**RE: Discharge of conditions 7, 8, and 16 of full planning permission F/19/86233
Land to the North and East of Boorley Green, Winchester Road, Botley, SO32 2UA**

SLR Consulting have also been requested to provide additional information for conditions 7, 8 and 16, to support application reference: DC/22/93211.

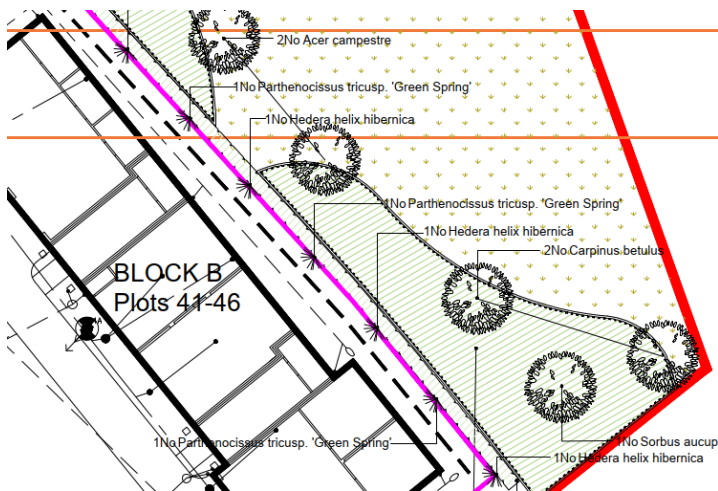
- 3) *Type of facing stone (in gabion baskets) - still says on gabion sections 'selected stone facing to clients spec'. Please provide full details of type of facing stone - size, shape, colour etc.*

The facing stone spec for the gabion baskets is 75mm-150mm natural and angular interlocking stone. Appearance as below, as noted previously the spec for the fill is 6N/P stone in accordance with series 600 of the DMRB:
